Considerations and discussion around an optimized link budget for 400GBASE-DR4

- towards TX OMA reduction and PAM4 PMDs alignment -

Gary Nicholl/ Marco Mazzini/Matt Traverso

400GBASE-DR4: 802.3bs draft 1.0 link budget.

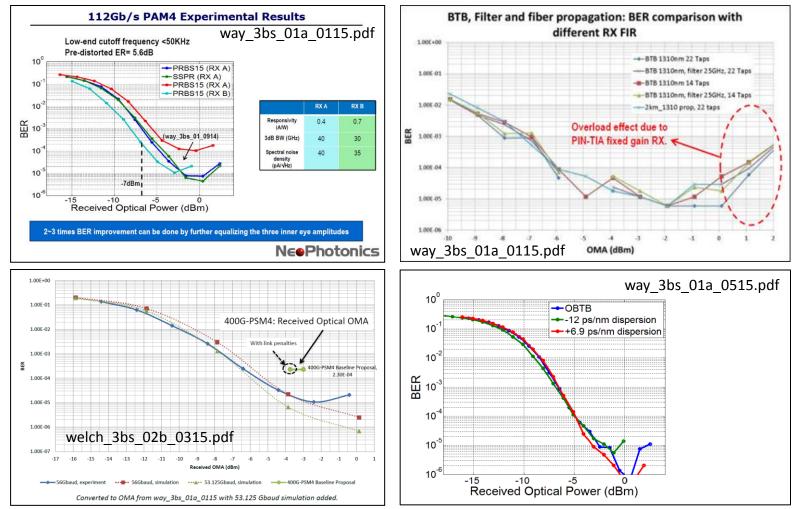
Current 400GBASE-DR4 link budget includes a margin of 0.15dB ([TX OMA_{innner} – TDP] – CH IL - RX Sens) which takes into account MPI penalty (0.5dB) into.

Table 122-6-400GBASE-DR4 transmit characteristics

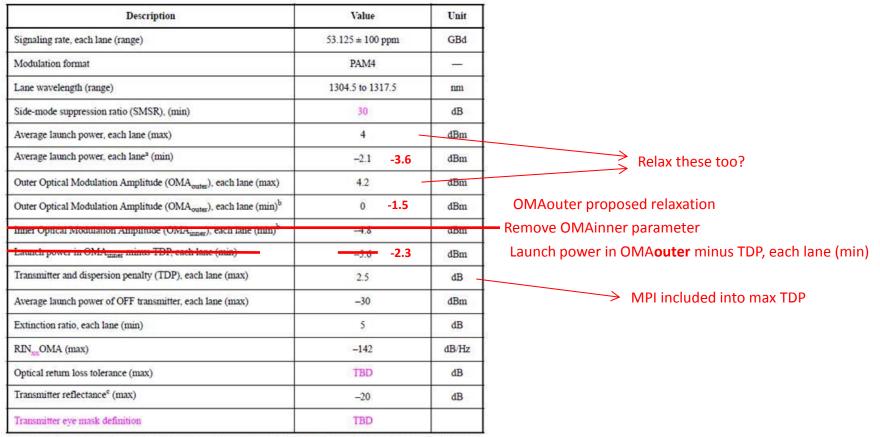
- Table <u>122-6</u>:
 - TX OMAouter : from 0 to -1.5dBm

- remove TX OMAinner from table 122-6 and replace with OMAouter TDP = -2.3 dBm.
- Incorporate MPI penalty into max TDP penalty of 2.5dB.
- Table <u>122-7</u>:
 - RX sensitivity (OMAinner) : from -9.25 to -10.3dBm
- Table 122-8:
 - Add : Allocation for modulation penalties = 5dB.

This align with 400GBASE-FR8/LR8 TX/RX characteristics of Table 123-7. Proposed changes to transmitter characteristics are in red.

Proposed 400GBASE-DR4 link budget.

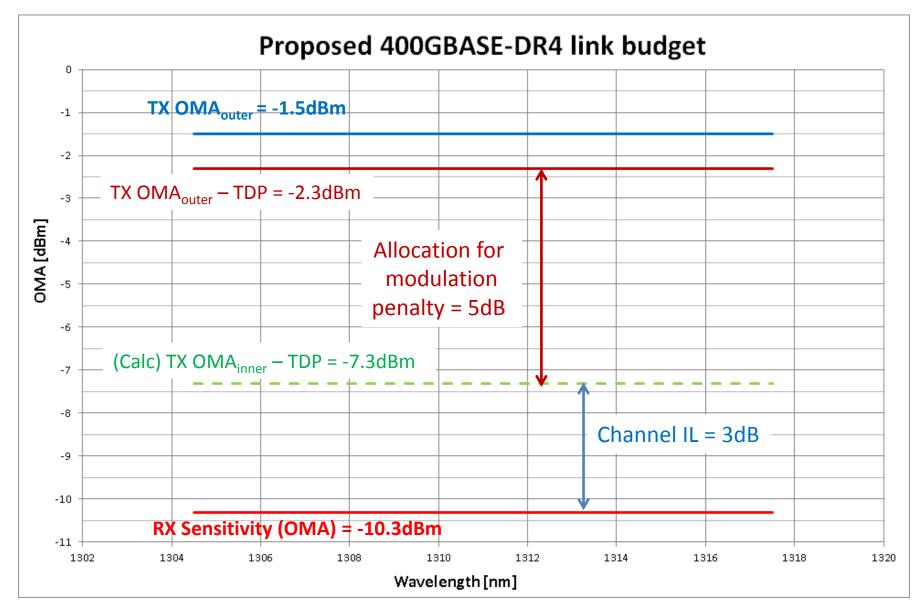
Proposed changes to receive and link budget characteristics are in red.

Include MPI penalty into allocation into max TDP penalties Add a row: Allocation for modulation penalties of 5dB
